Re: Aztec Special Education Facility
Request for Certificate of Occupancy- Transportation Development
Architect's Stamp dated 09-22-15 (H20-D033)
Certification dated 01-12-17

Re: Aztec Special Education Facility
Request for Certificate of Occupancy- Transportation Development
Architect's Stamp dated 09-22-15 (H20-D033)
Certification dated 01-12-17

**Re: Aztec Special Education Facility
2611 Eubank Blvd NE
Request Permanent C.O. - Accepted
Engineer's Stamp dated: 7/31/2015 (H20D033)
Certification dated: 1-18-17**

ASI-042

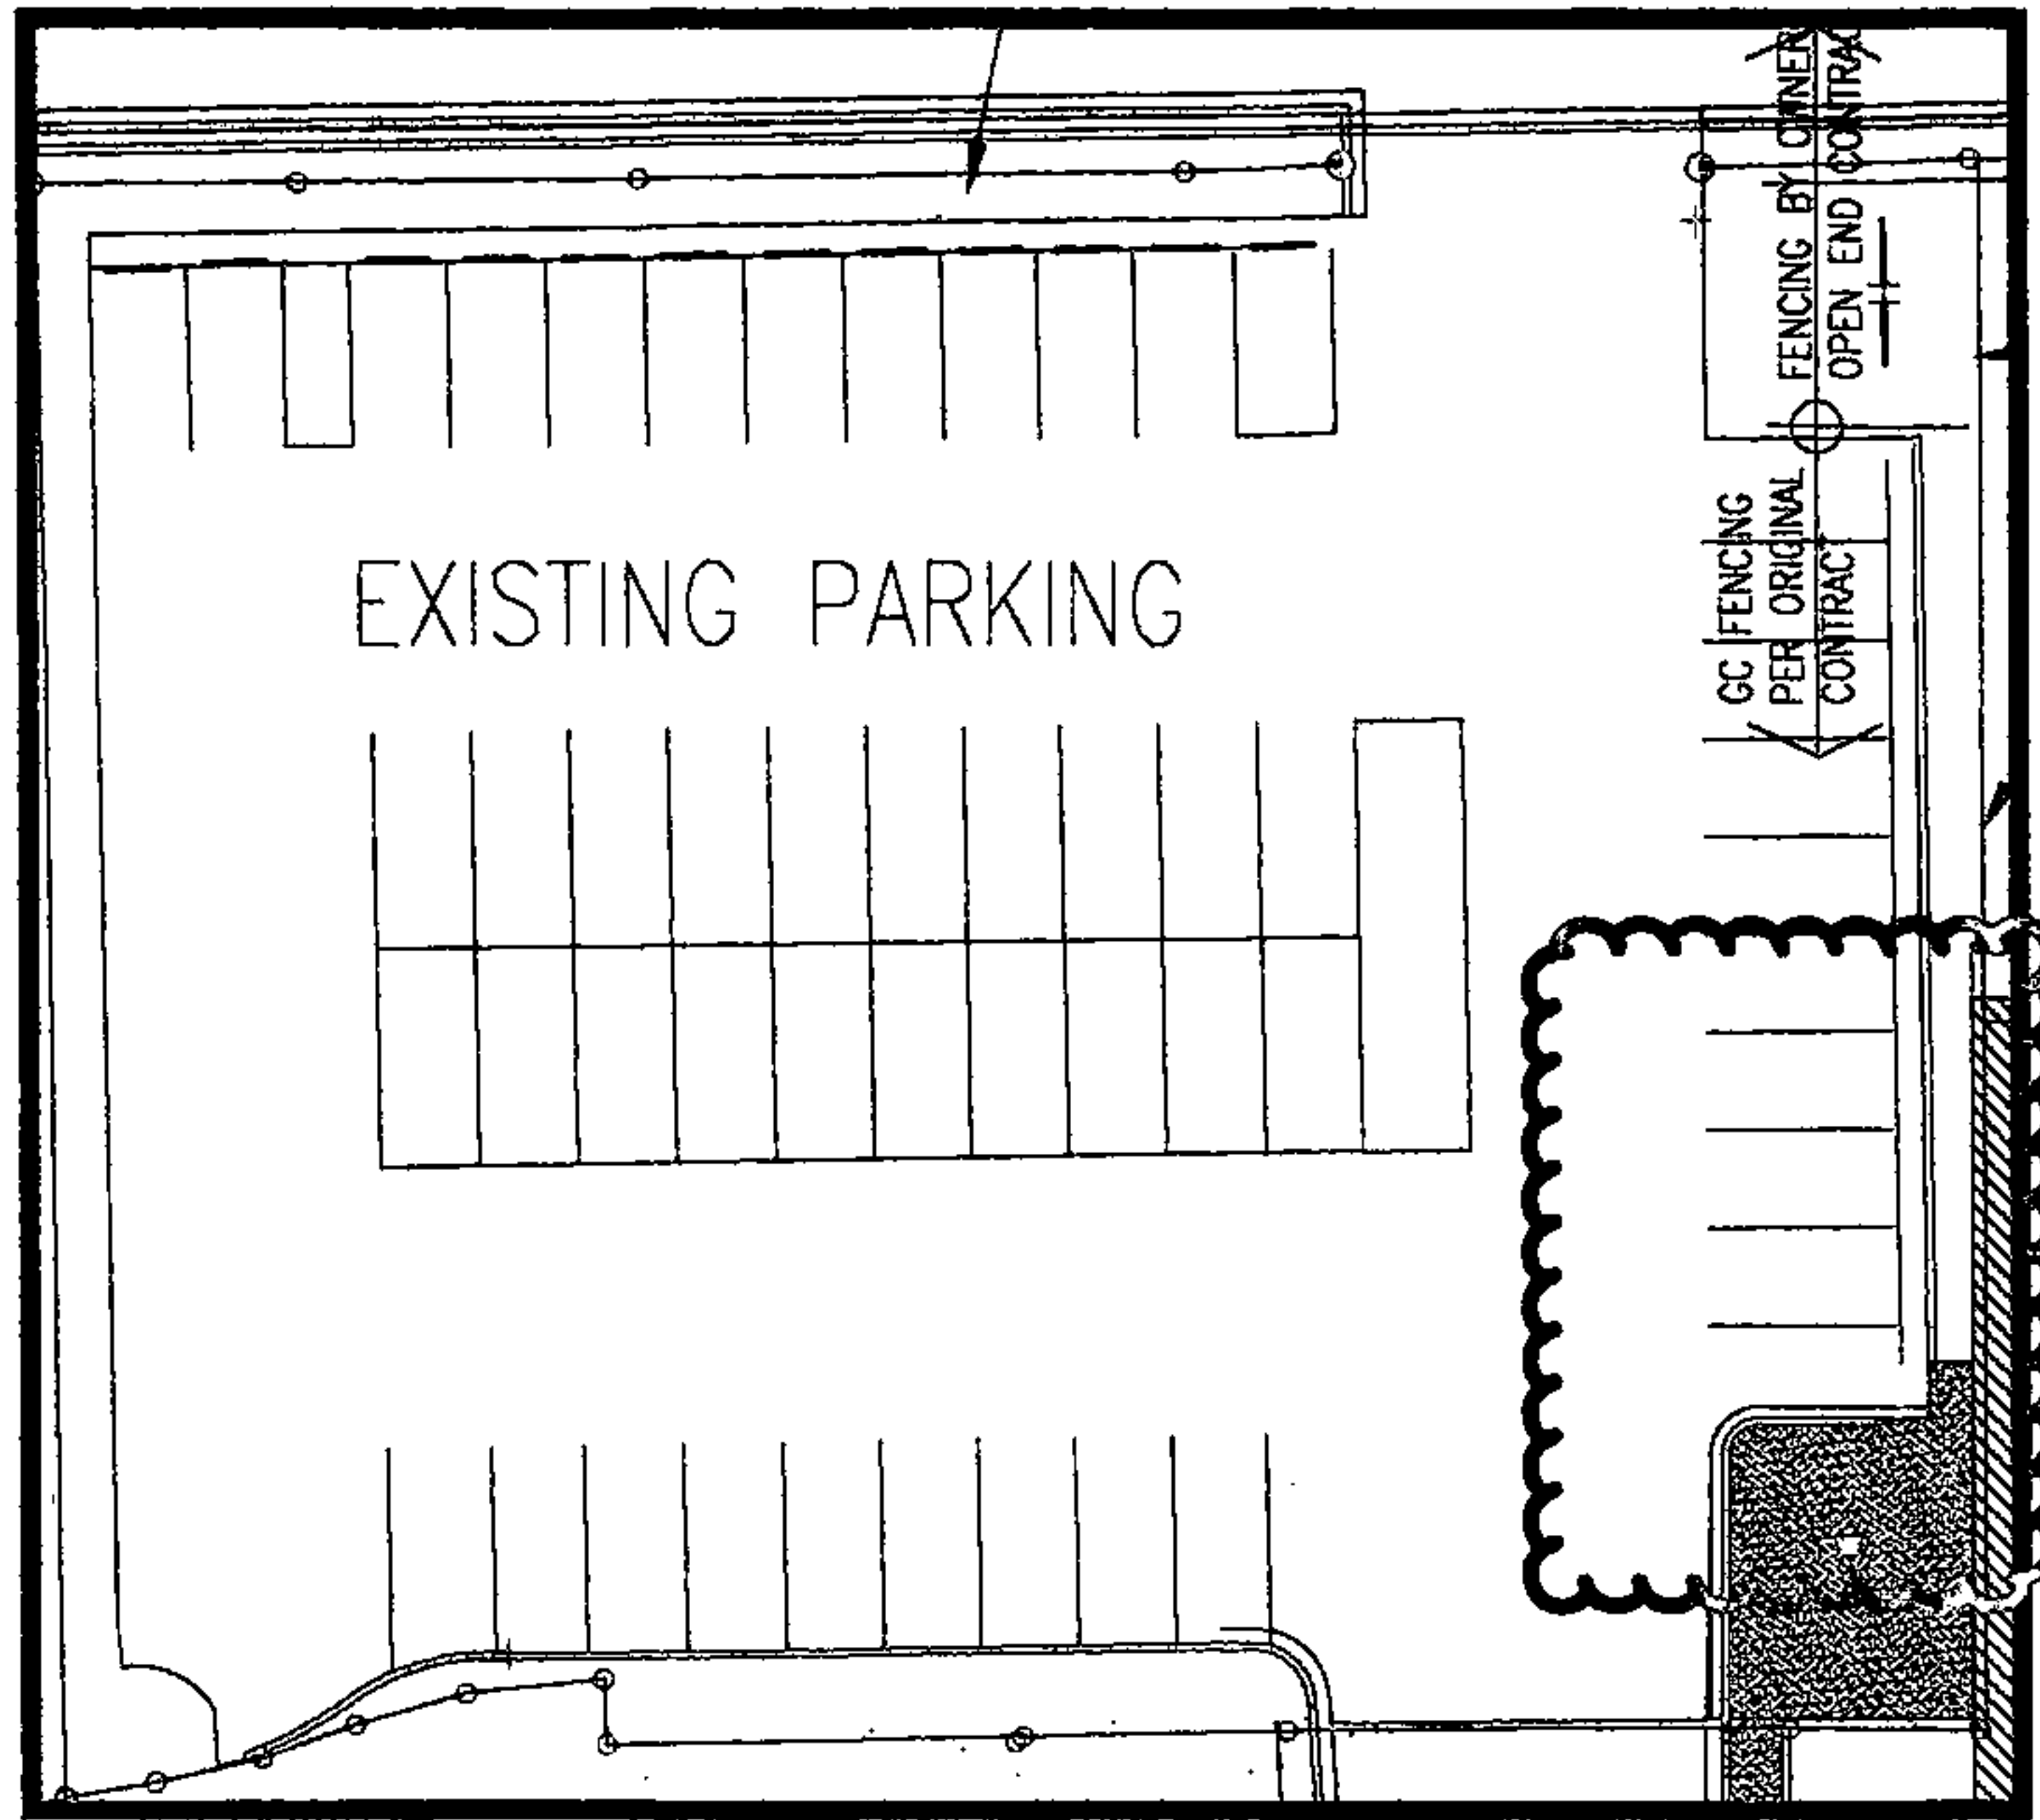
- The site had construction equipment, material, and debris throughout the parking lot. The site should be safe and ready for use by the general public at CO.
- The ADA access ramp on exhibit ASI-042 did not have the prefab detection pad or detectable warning surface as indicated on the plans.
- Motorcycle space should be labeled.
